Interactive comment on “TerrSysMP-PDAF (version 1.0): a modular high-performance data assimilation framework for an integrated land surface–subsurface model” by W. Kurtz et al.

W. Kurtz et al.

Received and published: 26 January 2016

Fig. 1. Simulated soil water content at four verification nodes ($x=2500\text{m}$, $y=1500/2500/3500/4500\text{m}$, from north to south) for April–June 2013. Upper row: open-loop simulations; lower row: assimilation.

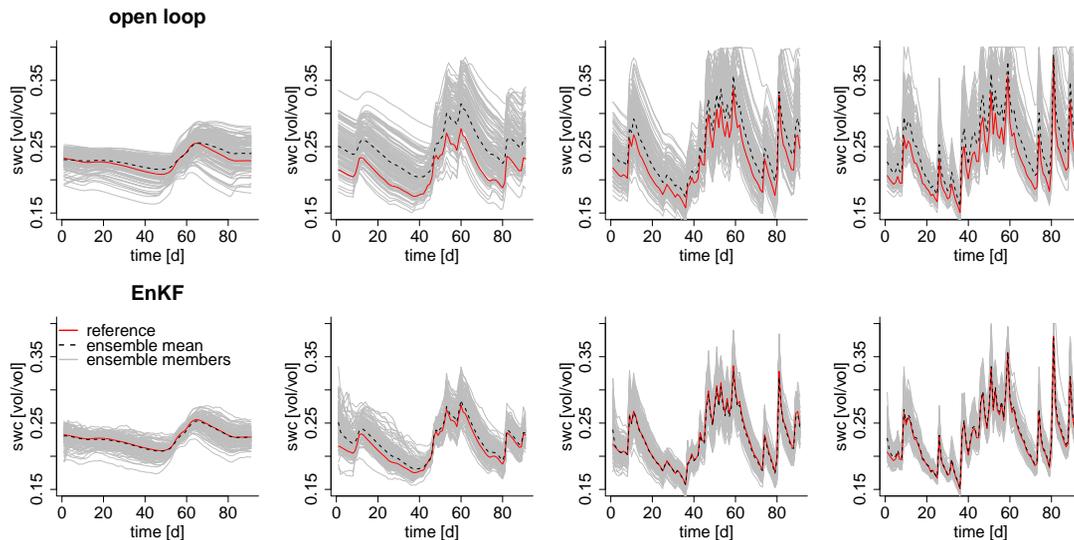
Figure 8 shows four time series plots of Soil moisture at four locations. Are these four locations where there are observations. It's not very informative to validate using the same measurements that were used in the assimilation. Could you not find 4 points distal (or in between the assimilated measurements) for validation?

Reply: You are right. Fig. 9 shows predicted soil moisture values at four observation locations. In order to make this comparison more objective, we also used four independent points for verification which are in between the observation points ($x=2500\text{m}$, $y=1500/2500/3500/4500\text{m}$). However, the conclusions for these different verification points (see Fig. 1 below) are quite similar to the ones from the previous figure. We will show the results from the independent verification points in the revised manuscript.
